UNITED STATES PATENT AND TRADEMARK OFFICE

APPLICATION NO.	FILING DATE	FIRST NAMED INVENTOR	ATTORNEY DOCKET NO.	CONFIRMATION NO.
10/782,515	02/11/2004	John P. Maguire	52418.830004.US0	4719
26582	7590	07/09/2007		
HOLLAND & HART, LLP P.O BOX 8749 DENVER, CO 80201			EXAMINER PAINTER, BRANON C	
			ART UNIT	PAPER NUMBER
			3609	
			MAIL DATE	DELIVERY MODE
			07/09/2007	PAPER

Office Action Summary	Application No.	Applicant(s)	
	10/782,515	MAGUIRE ET AL.	
	Examiner	Art Unit	
	Branon C. Painter	3609

DETAILED ACTION

Reproduced from U.S. Patent No. 5,571,229

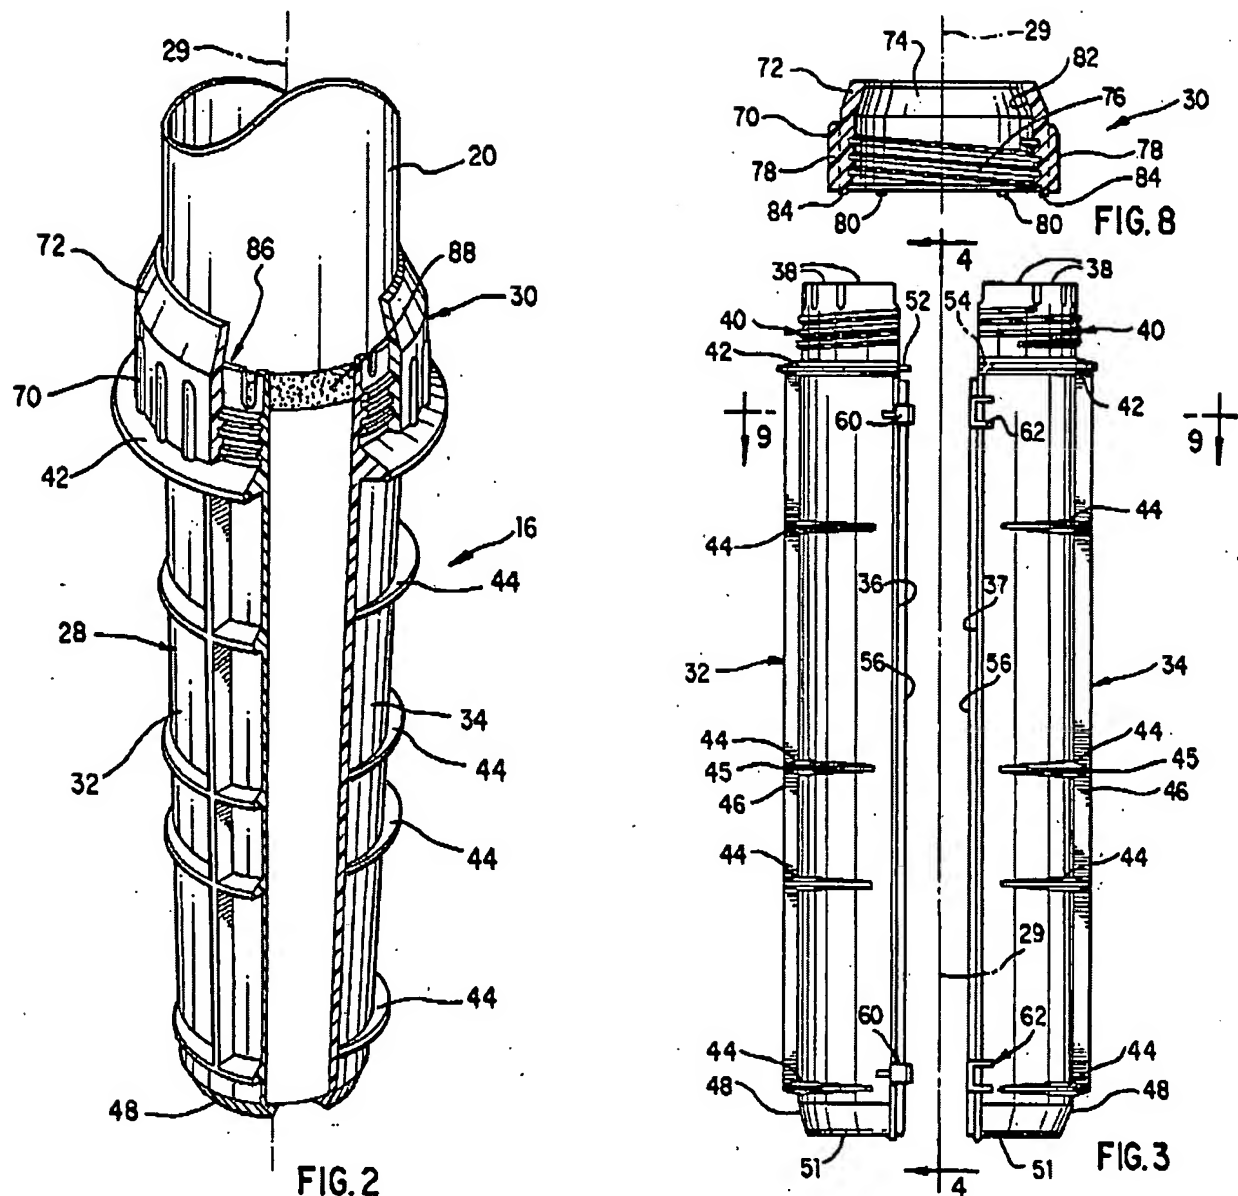
13. Claims 1, 5, 8, 9, and 12-17 are rejected under 35 U.S.C. 102(b) as being anticipated by Fitzsimmons et al. (U.S. Patent No. 5,571,229).
14. Regarding claim 1, Fitzsimmons et al. discloses a ground sleeve having all of the applicant's claimed structure, including:
- a. "a body defining a cavity, wherein the body has top and bottom ends..." ("ground sleeve body" 28 with top end "shoulder" 42 and bottom end "inwardly tapered portion" 48, Fig. 3).
 - b. "...a wedge portion that connects to the body using threads, wherein the wedge portion encircles a support member received in the cavity..." ("cap" 30, Fig. 8 encircling "support pole" 20, Fig. 2).

- c. "...a compression ring disposed in the cavity, wherein the compression ring expands and contracts in response to movement of the wedge portion relative to the body..." ("ground sleeve body" 28 from "shoulder" 42 to "tabs" 38, Fig. 3).
- d. "...wherein the body and web portion are corrosion resistant." ("Further, it is considered within the scope of this invention to utilize any sufficient strength weather-resistant and non-corrosive material to form the cap 30 and/or the sleeve body 28," column 6, lines 48-51).
- e. The examiner notes that the upper threaded portion of ground sleeve body 28 (mapped onto the wedge portion) is disposed inward towards the support member and into the cavity when engaged with cap 30.

15. Regarding claim 5, Fitzsimmons et al. discloses a wedge portion with an upper surface substantially flush with the upper surface of the anchor body when engaging the support member (top of "cap" 30 and "tabs" 38, Fig. 2).

16. Regarding claim 8, Fitzsimmons et al. discloses a means for preventing the body from rotating relative to a ground surface in which the anchor is mounted ("longitudinal flanges" 46, Fig. 3).

17. Regarding claim 9, Fitzsimmons et al. discloses an anti-rotation tab ("longitudinal flanges" 46, Fig. 3).
18. Regarding claim 12, Fitzsimmons et al. discloses an anti-rotation tab connected approximately midway between the top and bottom ends of the body ("longitudinal flanges" 46, Fig. 3).

19. Regarding claim 13, Fitzsimmons et al. discloses a bottom plate connected to the bottom end of the body ("transverse end wall" 51, Fig. 3) and a spacer inside the cavity at a connection between the bottom plate and bottom end of the body, wherein the spacer spaces the support member away from the bottom portion when the support member is received ("inner race surface" 50, Fig. 4).

20. Regarding claim 14, Fitzsimmons et al. discloses a spacer that comprises a chamfered bottom corner that contacts a lower end of the support member ("inner race surface" 50, Fig. 4).

21. Regarding claim 15, Fitzsimmons et al. discloses a spacer disposed in the cavity, wherein the spacer abuts the support member and spaces it away from other portions of the body ("inner race surface" 50, Fig. 4).

22. Regarding claim 16, Fitzsimmons et al. discloses means for receiving the support member ("ground sleeve body" 28 with top end "shoulder" 42 and bottom end "inwardly tapered portion" 48, Fig. 3); means for releasably securing the support

member by compressing a compression ring around the support member in response to a torsional force exerted on the means for receiving ("ground sleeve body" 28 from "shoulder" 42 to "tabs" 38, Fig. 3); means for preventing the anchor from moving relative to the ground surface in which the support member is positioned ("longitudinal flanges" 46, Fig. 3).

23. Regarding claim 17, Fitzsimmons et al. discloses means for centering a lower end of the support member ("inner race surface" 50, Fig. 4).

Reproduced from U.S. Patent No. 3,685,237

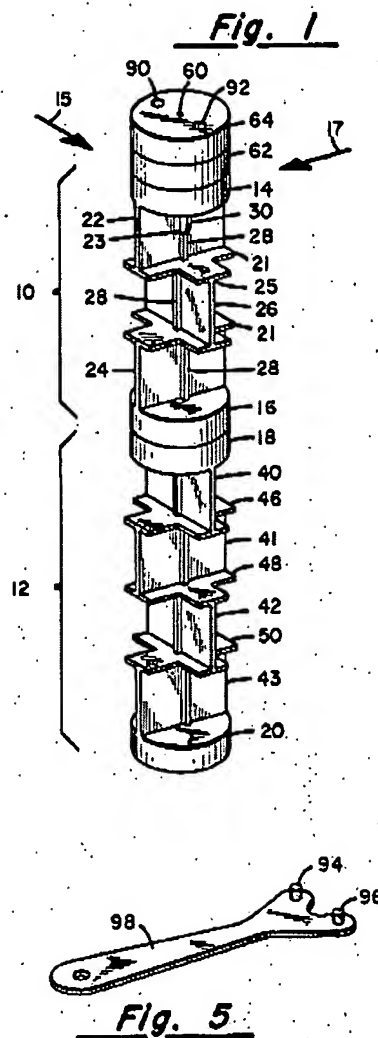
- c. Johnson discloses an upper surface with holes for receiving pins on a key used for tightening (top surface with "holes" 90 and 92, Figs. 1 and 5) [claim 3], and that two of the holes are disposed opposite each other ("holes" 90 and 92, Fig. 1) [claim 4]. Adding holes for use with a tightening element as taught by Johnson allows the wedge member to be secured more tightly than by hand.

- c. Johnson discloses an upper surface with holes for receiving pins on a key used for tightening (top surface with "holes" 90 and 92, Figs. 1 and 5).

Reproduced from U.S. Patent No. 6,684,588

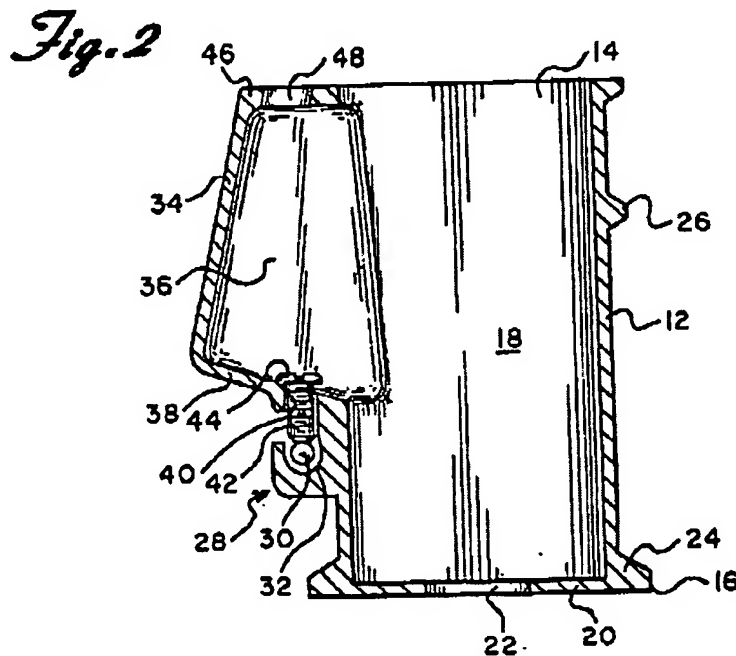
- c. Jones discloses an electrical grounding means attached to an anti-rotation tab that utilizes a ground screw (tab "clamp" 28 with "conductor" 30 and "screw" 42, Fig. 2) [claims 10 and 11]. Adding a grounding screw to the anti-rotation tab as taught by Jones allows the sleeve and any metallic structures it touches to be electrically grounded as a precautionary measure against lightning strikes or other causes of voltage gradients.

- d. The examiner further notes motivation for combining the references as set forth in Jones: "Codes or regulations in many communities require that all metallic structural parts and fittings of a swimming pool such as metallic parts of the pool structure...be bonded or electrically interconnected in order to eliminate voltage gradients in the pool area" (column 1, lines 20-26).
